EASTBOURNE PARK DISTRICT PLAN -

REVIEW OF HYDROLOGY AND HYDRAULICS

MAY 1987

Binnie and Partners in association with the Institute of Hydrology

Fig. 5.1 Estimates of 100-year flood hydrograph

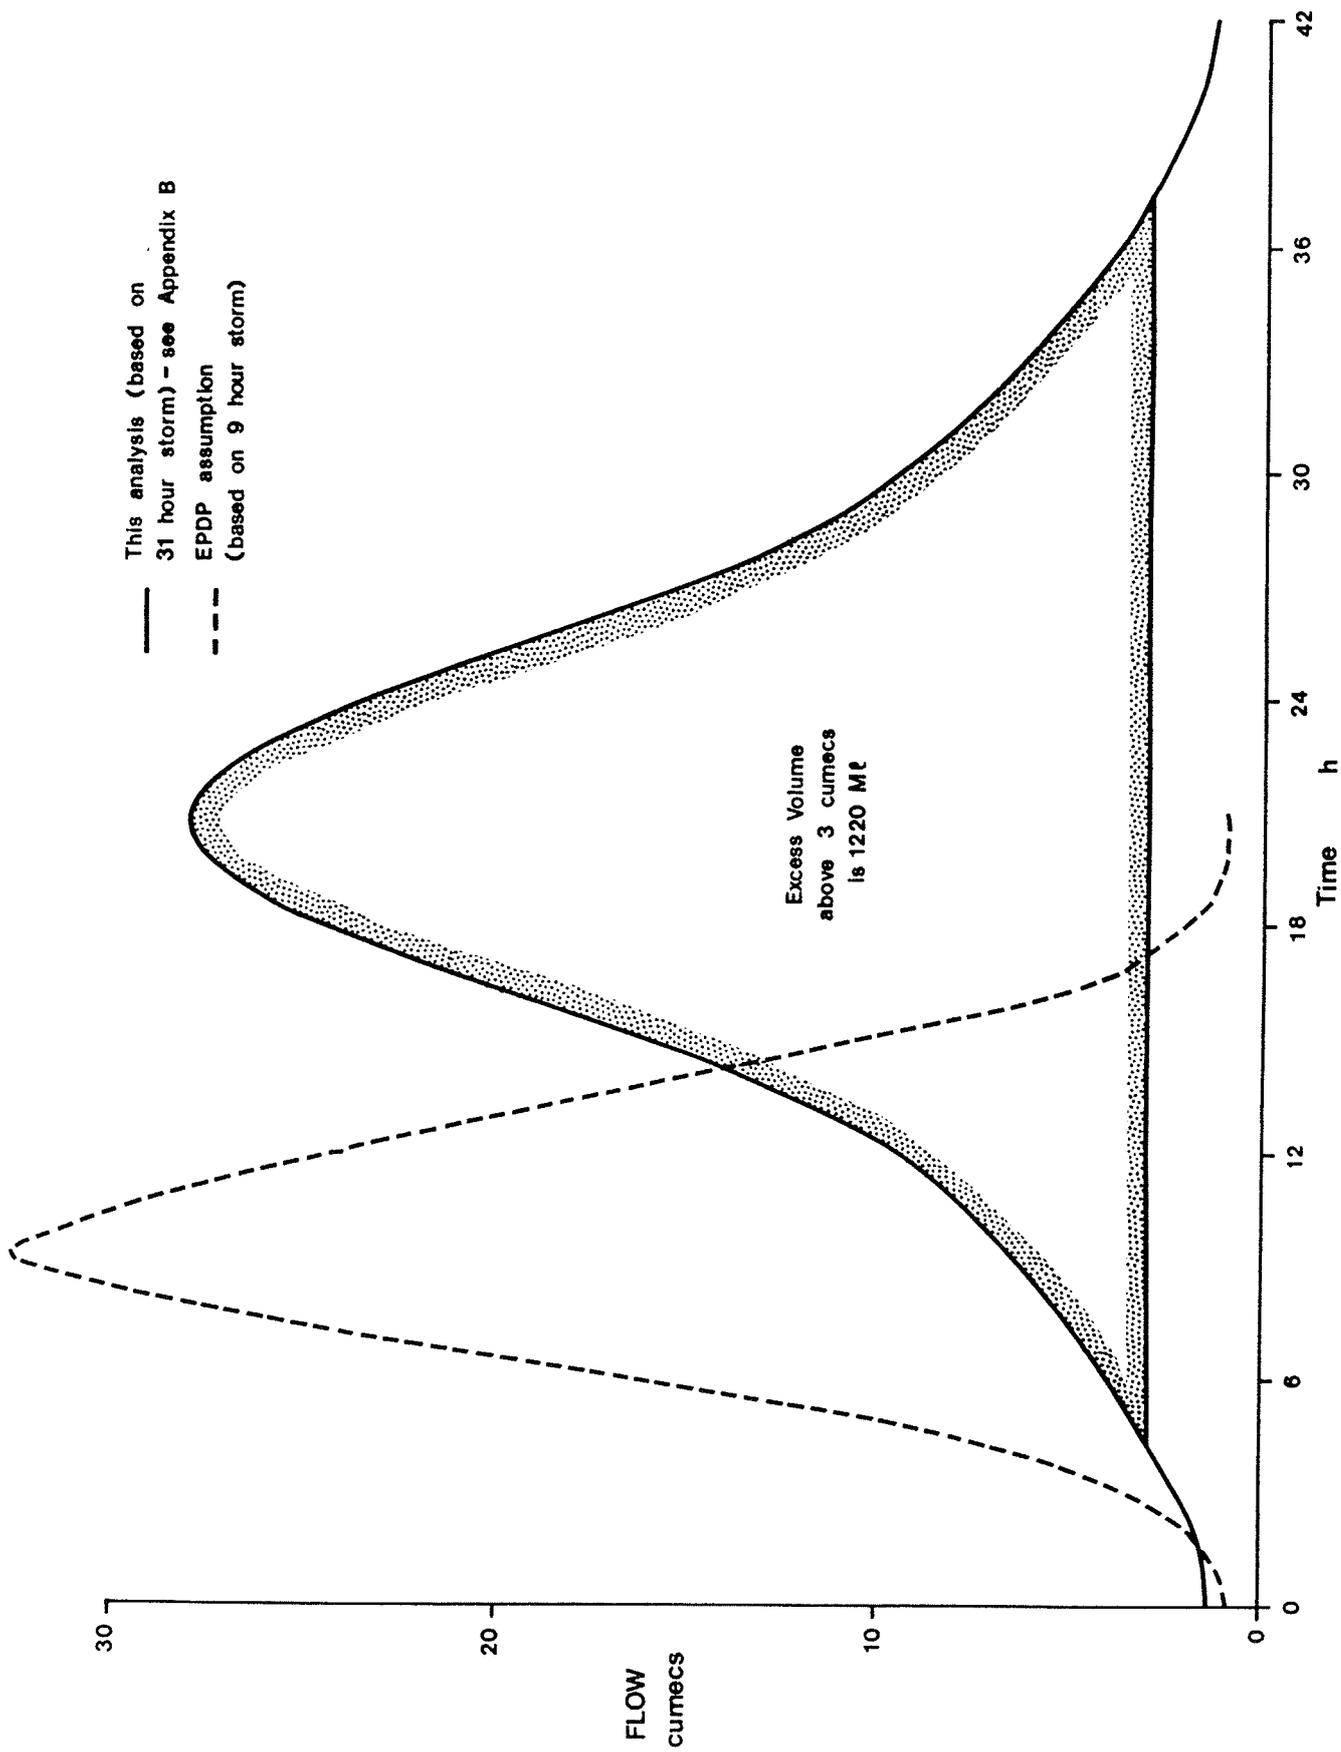
5.3 The 100 year flood hydrograph based on a 31 hour storm is shown in Figure 5.1. It is of a longer duration and has a significantly larger volume than the event adopted for use in the EPDP report. There are several reasons for this: some methodological and some interpretative. The following paragraphs consider in detail the more important aspects of the flood estimation.

Fig. 6.1 Catchment rainfall and Langney Bridge water level data for January 1986 event

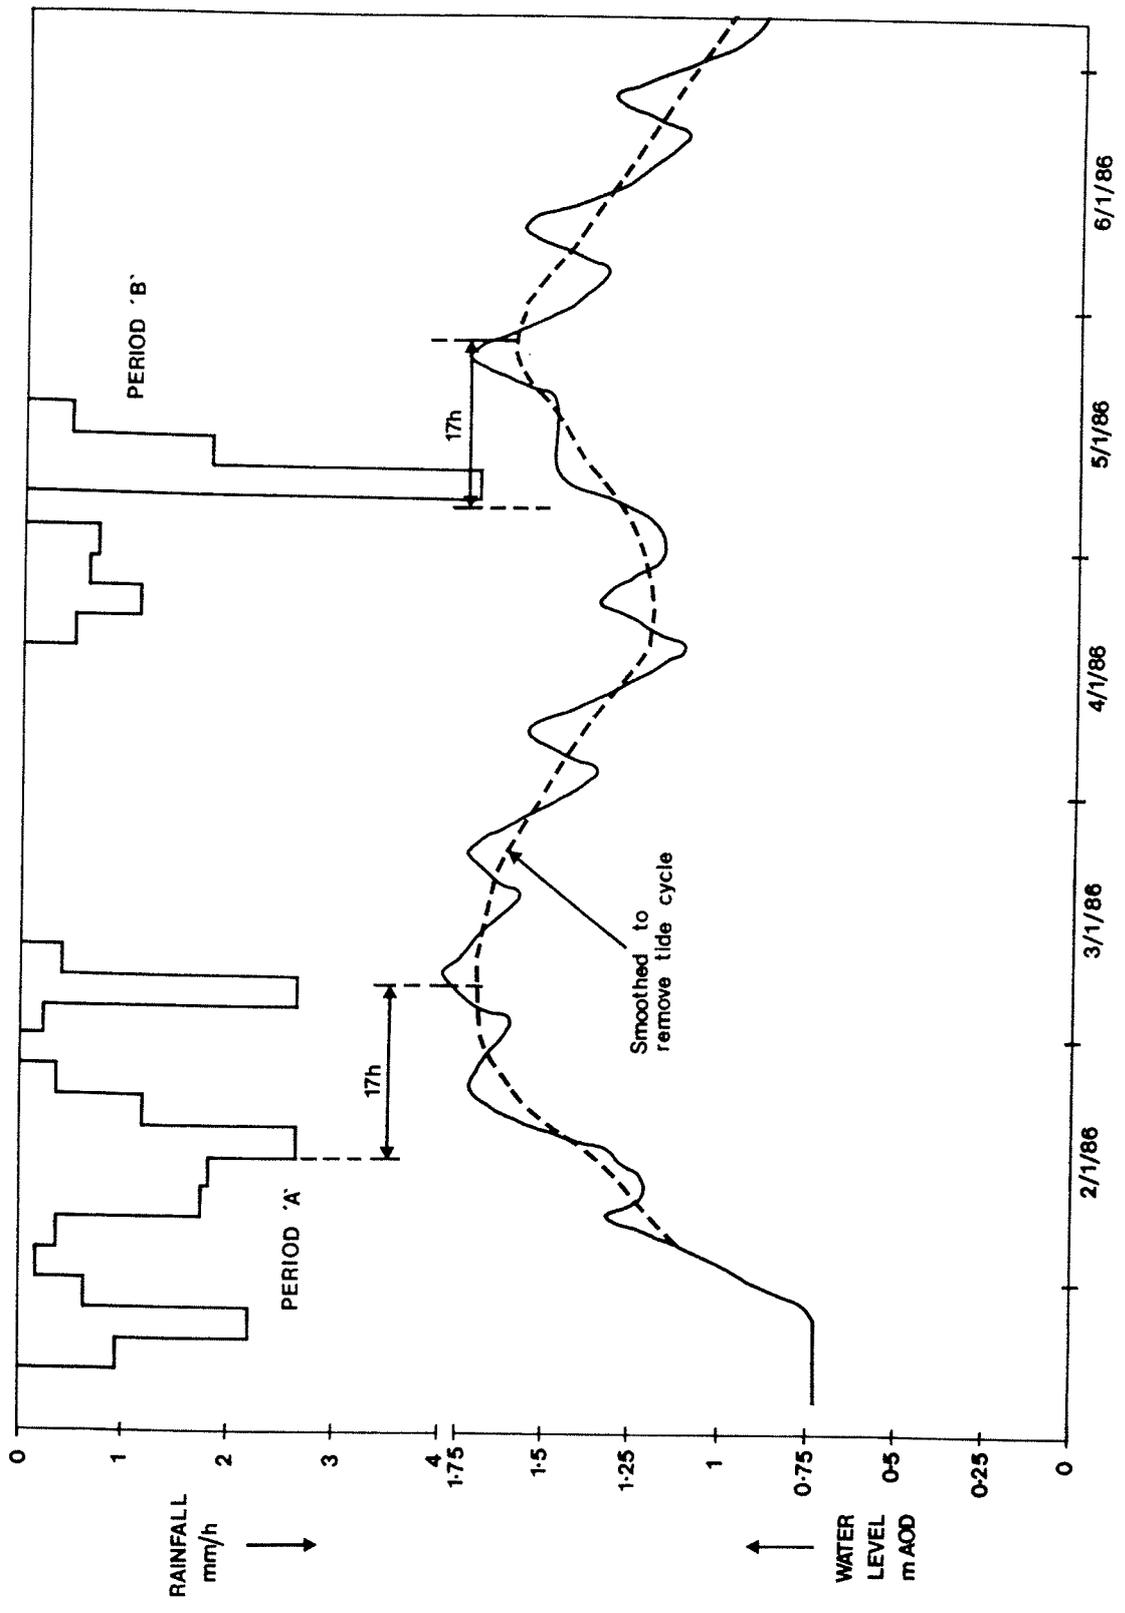
6.2 Figure 6.1 shows Langney Bridge water levels and catchment rainfalls for the period 1-6 January 1986. Catchment rainfall was assessed by reference to four daily raingauges (each located within 7km of the catchment centroid) and a recording raingauge at Wish Valley, Eastbourne.

6.3 Two features are of particular note in Figure 6.1:-

- (1) the tidal influence is marked throughout the period of flood runoff; and,
- (2) the effective response time of the catchment and flood plain storage to the heavy rainfall, far exceeds the duration of a single high tide. Therefore the degree of synchronization of the runoff peak with the tidal cycle would seem to be relatively unimportant.

magnitude and timing of outflows from Willingdon Levels could only be assessed within fairly wide limits. However, simply by smoothing over the tidal fluctuation in the Langney Bridge water levels, as shown by the broken line in Figure 6.1, it is possible to get a reasonable estimate of the time of the effective peak discharge from the Park.

6.5 Comparison of the peak discharge time with the centroid of the corresponding period of flood-producing rainfall (see Fig.6) yields a total characteristic response time of about 17 hours, of which 5 hours can be attributed to the catchment response and 12 hours to the delay imposed by the flood plain storage.

Graph showing calculation of flow in Langney Sewer at Langney Bridge  
Figure 7.1

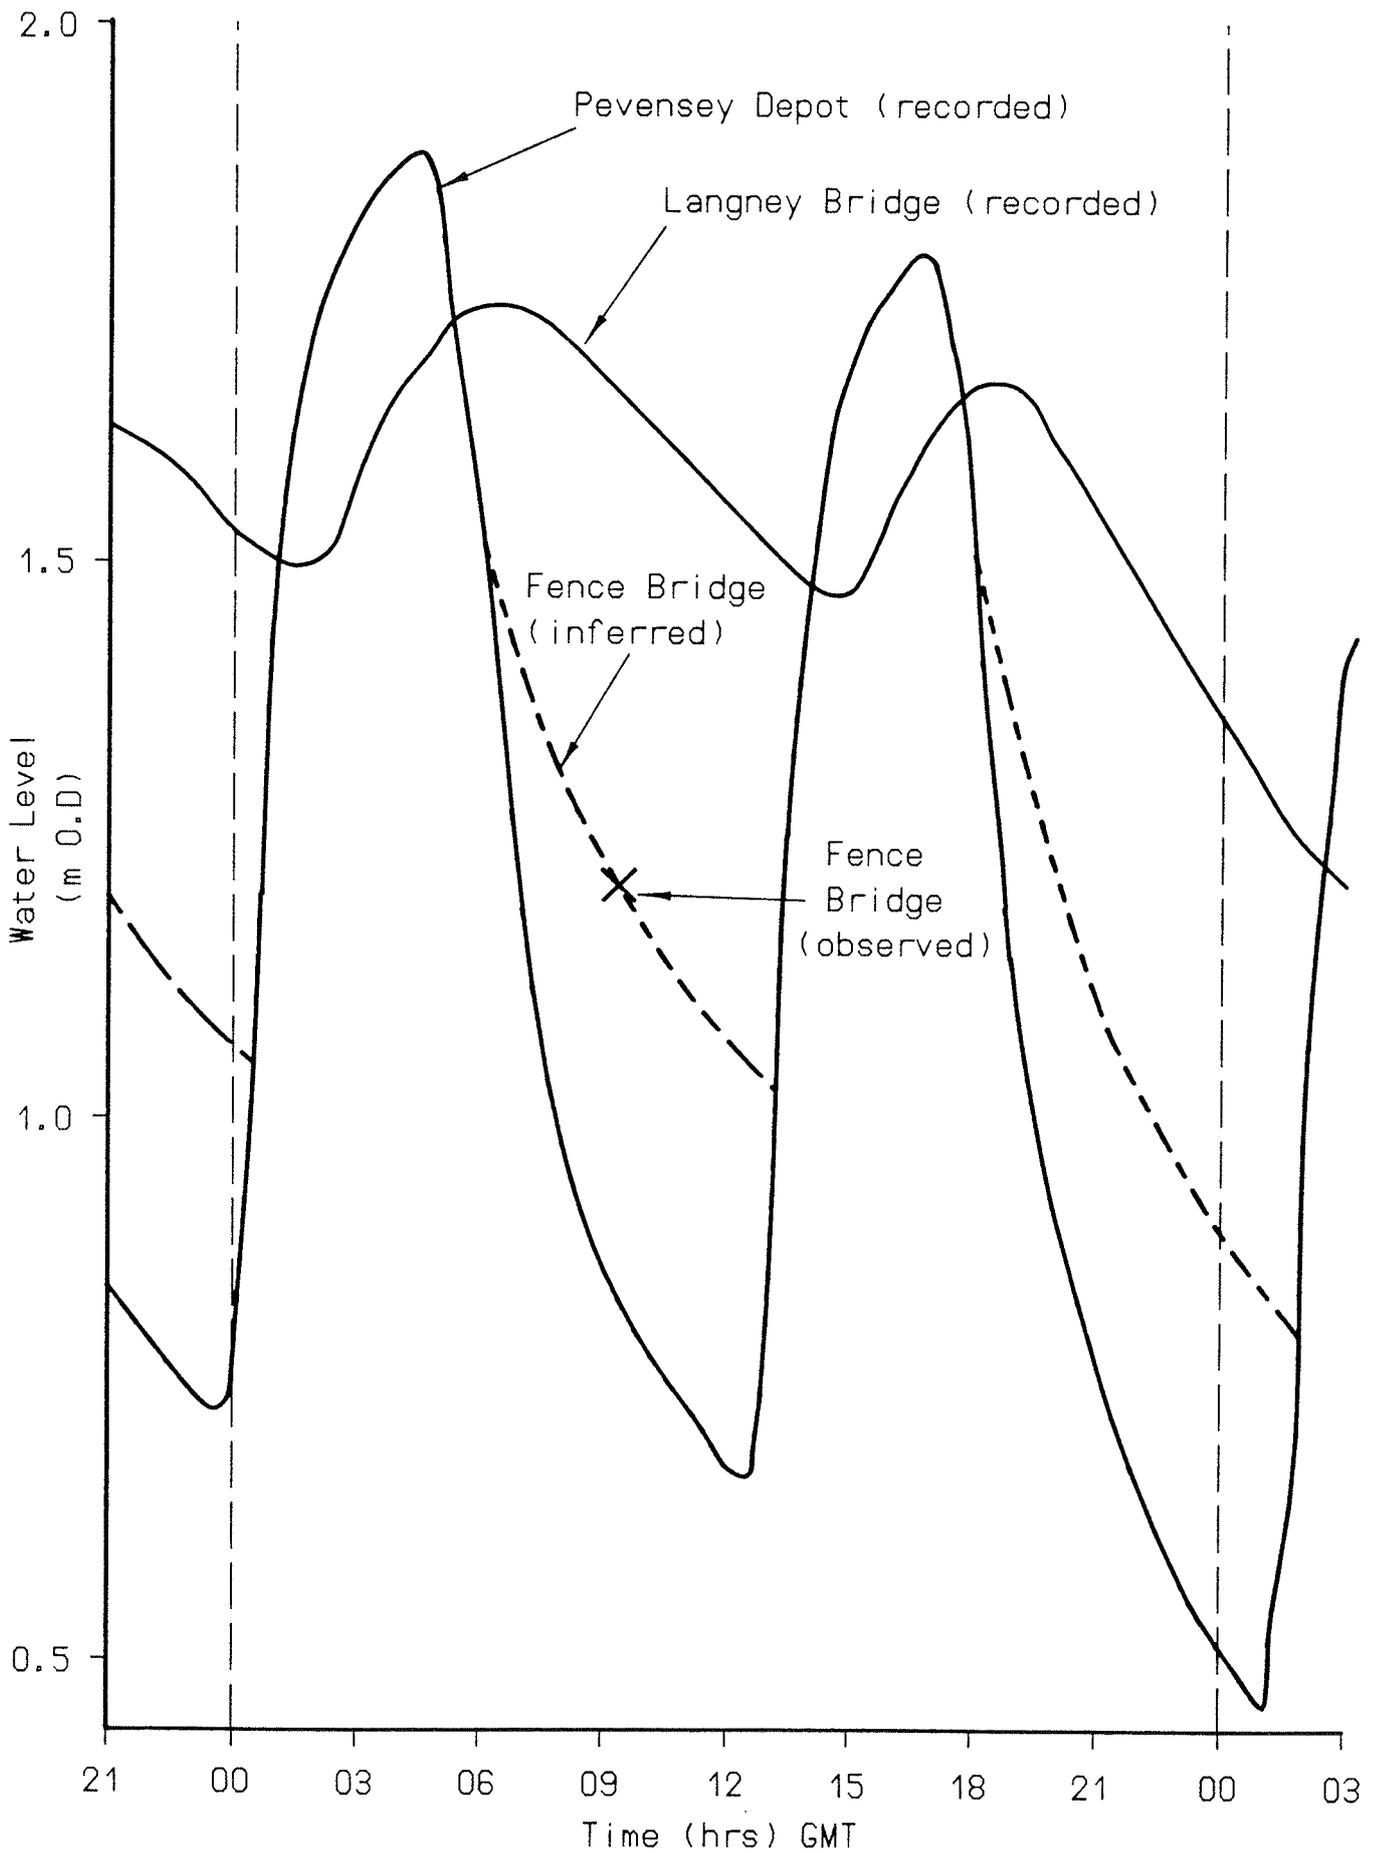
7.3 For the most part, the basic approach adopted is reasonable even though it incorporates several simplifying assumptions. The choice of friction factor is realistic and, although we have not been able to obtain a drawing showing details of the surveyed cross sections, we have no reason to doubt the calculation of the channel properties. One small

modification that is required is to allow for the loss of kinetic energy as the flow passes into Pevensey Haven via the constricted channel section at Fence Bridge Sluice. This would reduce the sewer discharge, when the water level is at 1.4 mOD, from 7.75 to 7.3 m<sup>3</sup>/s.

7.6 The results of our calculations are summarised on Figure 7.1. The figure shows how sensitive the discharge is both to the level difference between Langney Bridge and Fence Bridge and to the inflow

7.10 We have assessed the discharge at Langney Bridge for 3 January 1986 using Figure 7.1 on the basis of the observed or inferred water levels and assuming that direct drainage from the catchment downstream of Langney Bridge was half the runoff anticipated in the 100 year design storm. The results shown on Table 7.1 suggest an average discharge at Langney Bridge of between 2.7 and 3.9 m<sup>3</sup>/s depending on which water level curve is assumed to apply at Fence Bridge. This

Figure 7.2

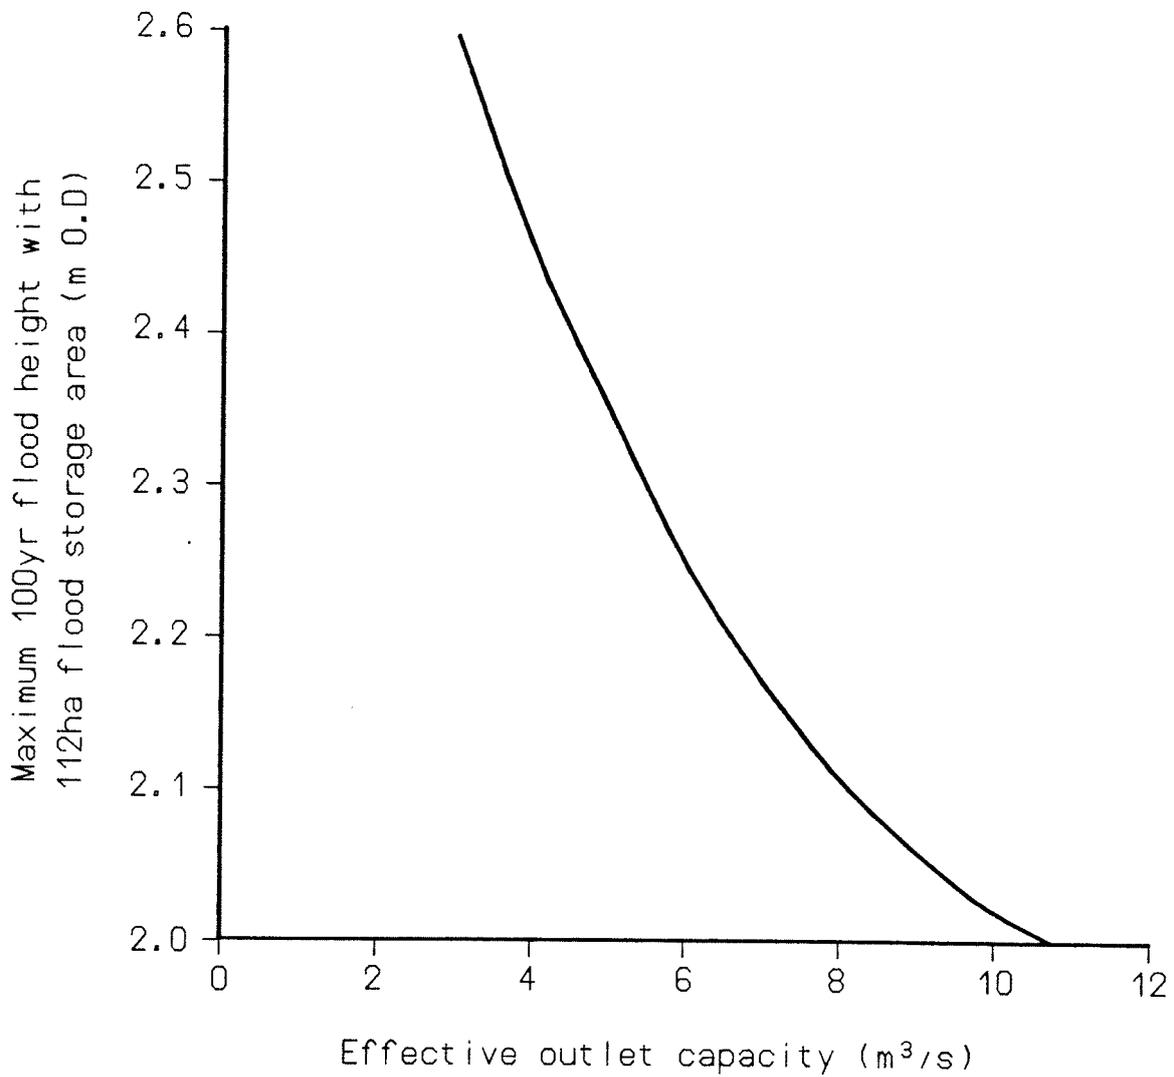
7.9 The water levels recorded at Langney Bridge and Pevensey Depot on 3 January 1986 are shown on Figure 7.2. This figure also shows the level at Fence Bridge at 9am as recorded by the sluice keeper. The observed value was 0.4m higher than the contemporary level recorded at Pevensey Depot. A possible tide curve for Fence Bridge based on this observed level has been sketched on Figure 7.2. The level records indicate that levels at Pevensey Depot were higher than those at Langney Bridge for a total of 8 hours on 3 January 1986.

**Relationship between effective outlet capacity and maximum 100yr flood height on Willindon Levels**  
**Figure 7.3**

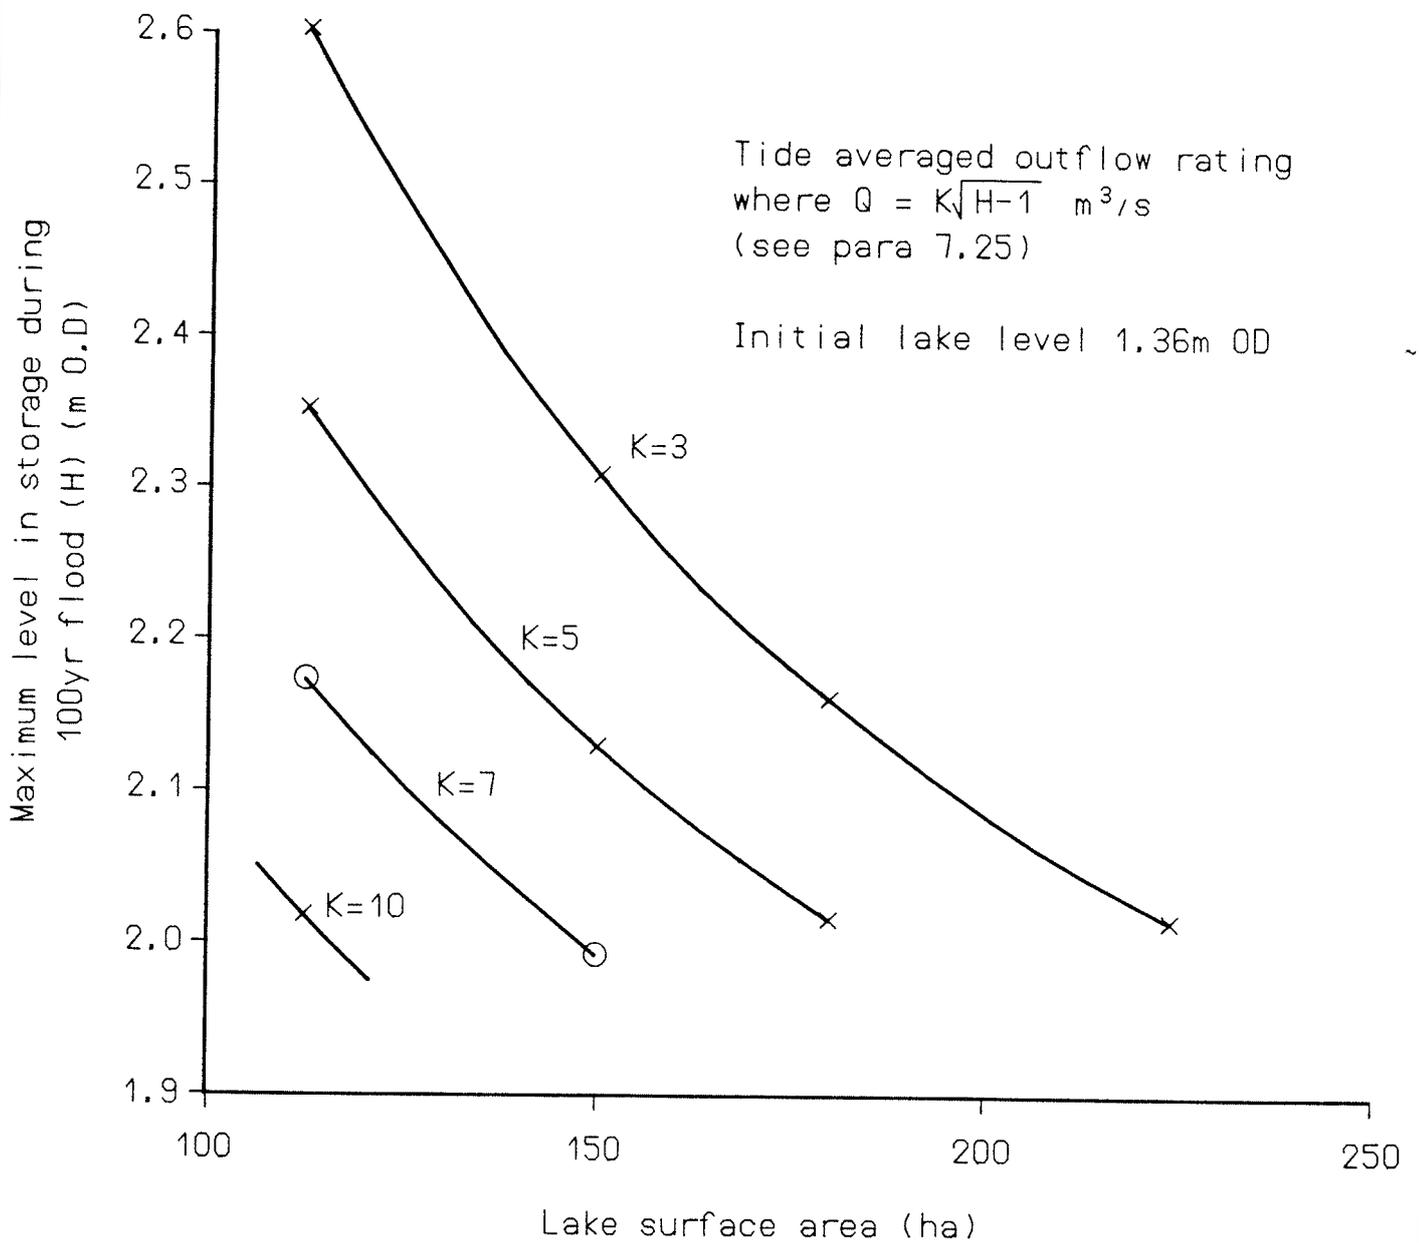
7.26 The effects of routing the updated 100 year design flood through the 112 ha lake area proposed in the EPDP report is illustrated in Figure 7.3. This demonstrates that the existing 24 hour average combined outlet capacity of around 3.0 m<sup>3</sup>/s through West Langney and Crumbles Sewers at 2.0 m OD would cause peak levels in the Willingdon Levels lake system of about 2.6 m OD. In practice somewhat lower levels would be expected because of the flooding of low ground around the lake system. This figure also suggests that the existing outlet capacity would need to be trebled to prevent water rising above 2.0 m OD in Willingdon levels in the design storm.

7.27 The extra outlet capacity required in this situation could not easily be provided by modifications to either the West Langney or Crumbles Sewer channels. An alternative would be large tidal doors or a pumping station discharging into the proposed Crumbles Marina. A pumping station would need to be capable of discharging upto 8 m<sup>3</sup>/s during flood periods. Tidal doors would need to be capable of discharging upto 16 m<sup>3</sup>/s if they were tide locked for half the time. The size of the doors would depend critically on their design, particularly the period of tidelock, but we anticipate that an effective area of at least 5m<sup>2</sup> below + 1.0 m OD would be required.

Figure 7.3 illustrates the relationship between flood height and outlet capacity for a 100 year flood assuming 112 ha of storage lakes with a normal retention level of 1.36 m OD. A series of similar diagrams should be produced to embrace a much wider range of alternatives so that the most appropriate flood alleviation scheme for Willingdon Levels can be evaluated.
